<b>NASA Engineering and Safety Center Technical Report</b>	Document #: <b>RP-07-47</b>	Version: <b>5.1</b>
Title:	<b>STS-117 Hail Damage Repair Assessment</b>		Page #: 1 of 114

# **Space Transportation System (STS)-117 External Tank (ET)-124 Hail Damage Repair Assessment**

**May 24, 2007**

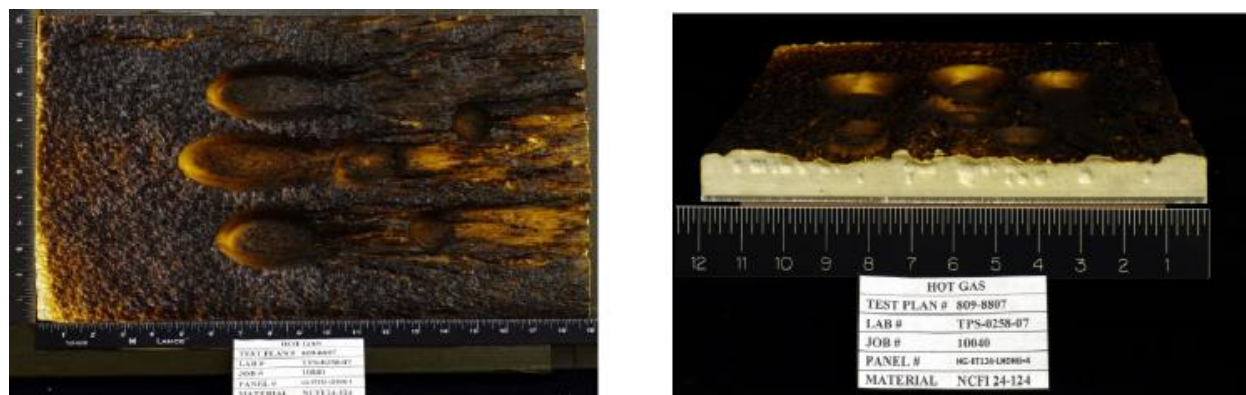
Unfortunately, a similar criteria for cavity dimensions has never been incorporated into the ET drawing system, thus any cavity type feature has historically been treated as if it was a surface wave even though the local flow physics of the two features is very different. The diameter of the cavity, at the SOFI outer surface was being used as the wavelength, and the depth of the cavity as the wave amplitude. Any cavity that did not meet the aerodynamic waviness criteria was repaired per the directions in MMC drawing 80901019010, which requires that the surface “smoothness” meet the aerodynamic waviness criteria.

The large number of hail damage sites, on ET-124, brought this issue to the SSP Thermal Panel several times during March of 2007. During the discussions, Marshall Space Flight Center (MSFC) Engineering noted that cavity heating test data had been developed and compared it to the literature after the STS-96 hail damage event. This work was presented to the SSP Thermal Panel on March 15, 2007 and a recommendation made that the “aerodynamic waviness” criteria not be used to size the cavity repairs. Doing so would cause good NCFI foam to be removed unnecessarily as cavities were enlarged to meet the aerodynamic waviness criteria. It was further recommended that the cavity walls be sloped to minimize the local heating to the downstream wall. The SSP Thermal Panel and NESC concurred with these recommendations. MSFC Engineering and the ET Project developed and implemented a revised cavity repair specification for the Sand and Blend and Use As Repaired (USR) or Use As Inspected (USI) repairs.

NESC concurs, on the basis of these tests and analyses, that the modified waviness criteria developed for ET-124 are acceptable for flight and the shape of the sand and blend repairs should

be optimized to minimize ice formation prior to launch, instead of only minimizing ascent heating.

**Figure F-6 – Repair Sorting and Recommended Augmentation**

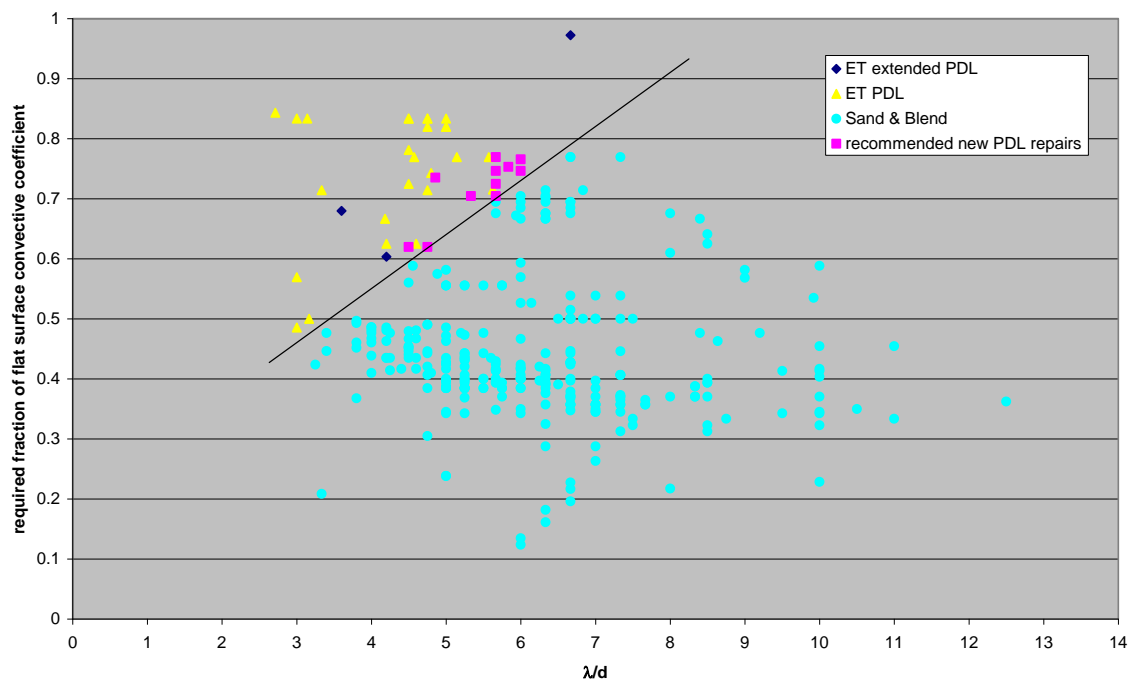
Figure J-6 also shows 11 repairs that were recommended as S&B by the ET Project that are above the dividing line and thus have icing potential that exceeds that of sites that had been designated for PDL repair. The NESC recommended to the project that these sites also be repaired with PDL. The ET Project accepted the recommendation.

**Figure G-5 – Relationship Used to Discriminate between Sand and Blend and PDL Repairs**

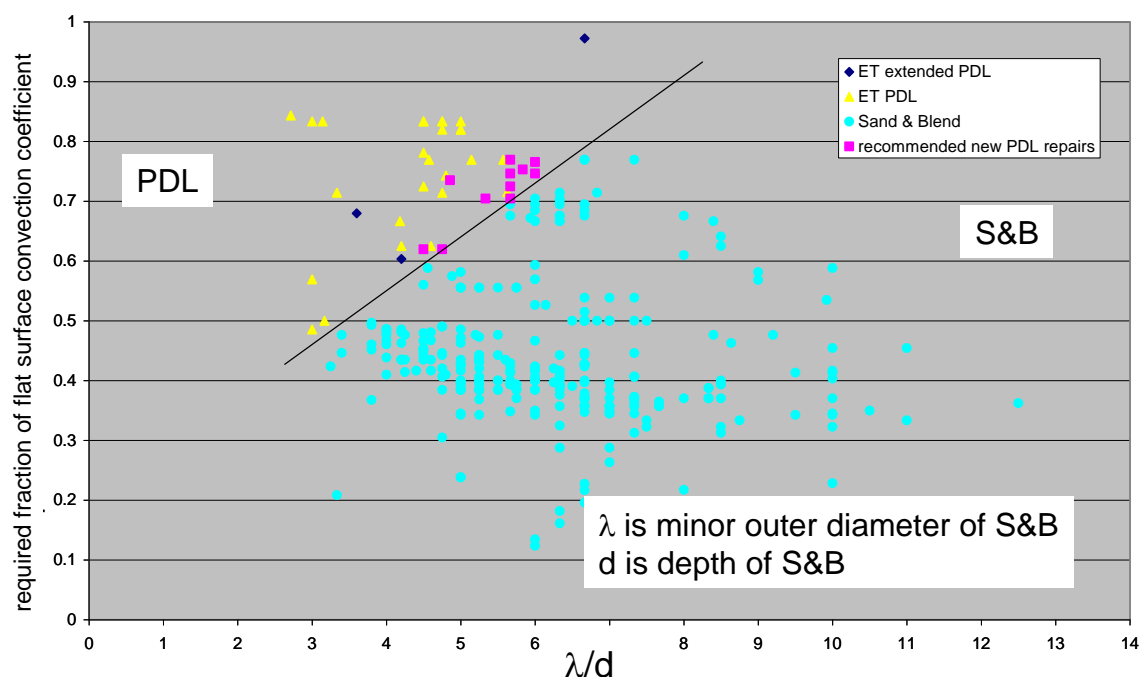
The choice between sand and blend repairs and PDL repairs for different hail damage locations was made based on a presumed relationship between the dimensions of the sand and blend cavity and the heat transfer at the bottom of the cavity as was detailed in Appendix F. Figure K-5 shows the selected relationship as a diagonal black line. If this line reflects the relationship between the fraction of flat surface convective coefficient and the geometry parameter, we have maintained 85percent launch probability May-October (per the ET analysis).

Figure 4 gives us a method of assessing the launch probability sensitivity to the location of the dividing line in Figure 5. If dividing line is off by a factor of 2, the critical value of F on a flat surface would need to double to prevent icing above the 15percent probability level. Figure 4 shows that if we select the critical value of F as 60 (2x the nominal 15percent level), the icing probability is less than 45percent (and the launch probability still exceeds 55percent). Therefore, we conclude that the selected sand and blend criteria yields a relatively robust icing launch probability.

**Figure I-1 - Maximum Expected Divot Masses Using the Two Algorithms**

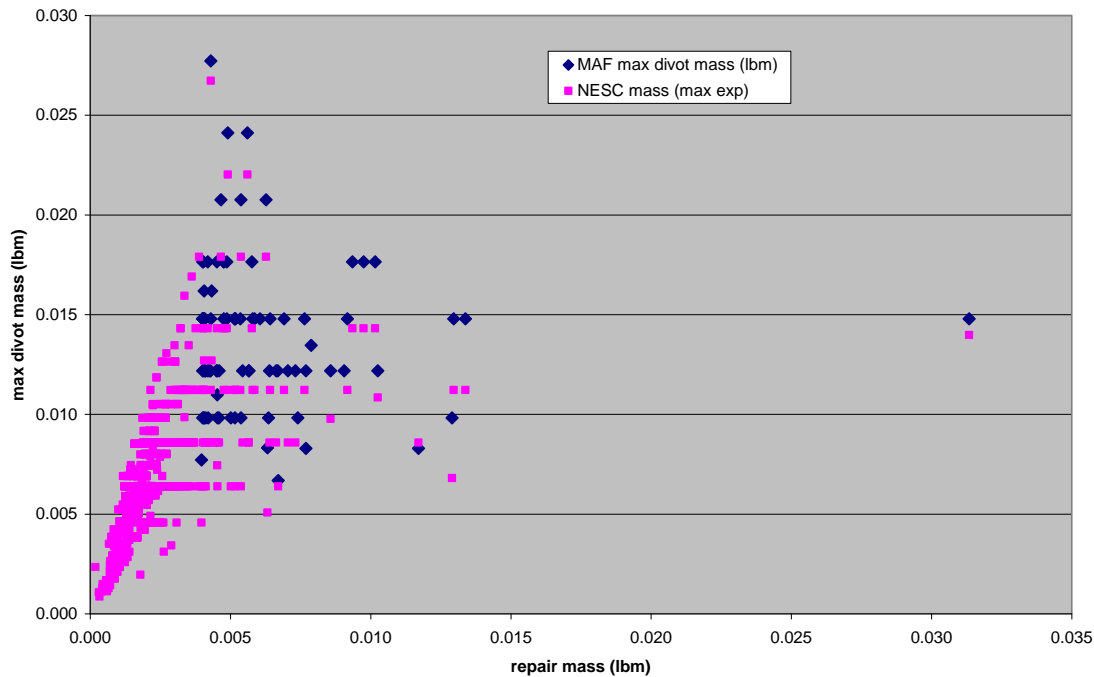
Figure L-1 plots the divot masses generated by the ET Project analysis and the NESC analysis. Even the figure shows that a very large number of possible divots greater than the deterministic limit of 0.004 lbm are not calculated are by the ET Project's algorithm.

Figure L-2 – Sorted Divot Masses

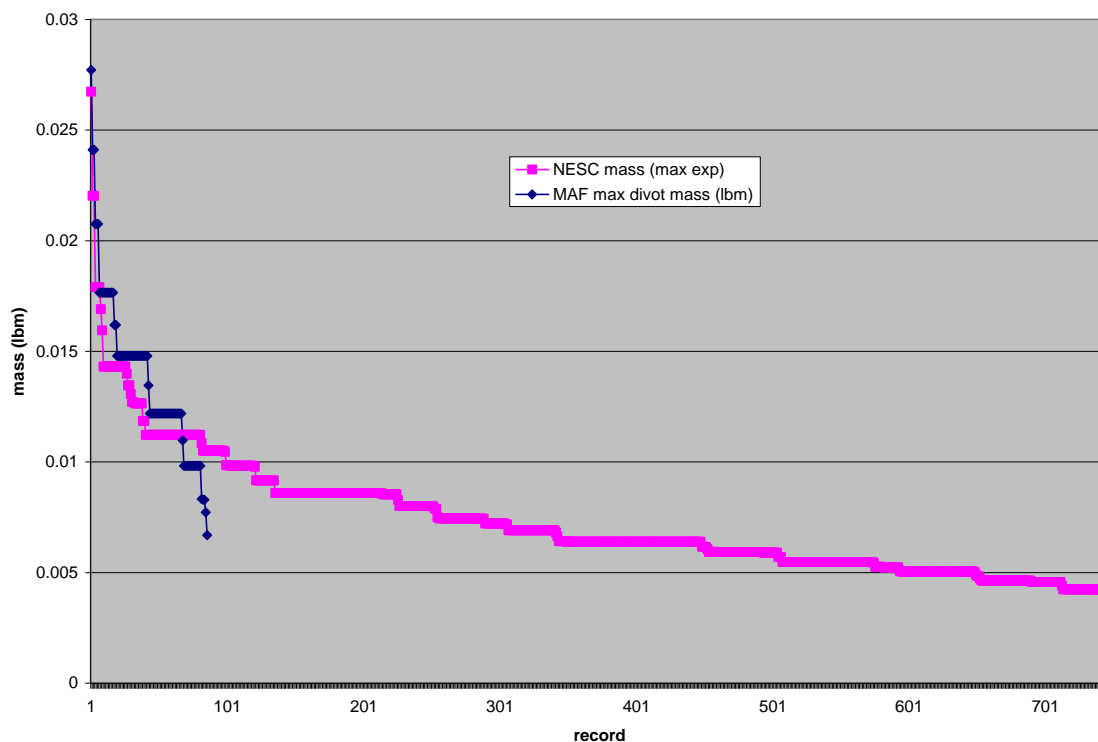
Figure L-2 plots sorted defect masses greater than 0.004 lbm obtained by the two algorithms. The figure shows the additional smaller masses between 0.004 and 0.010 lbm that are captured by the NESC method.
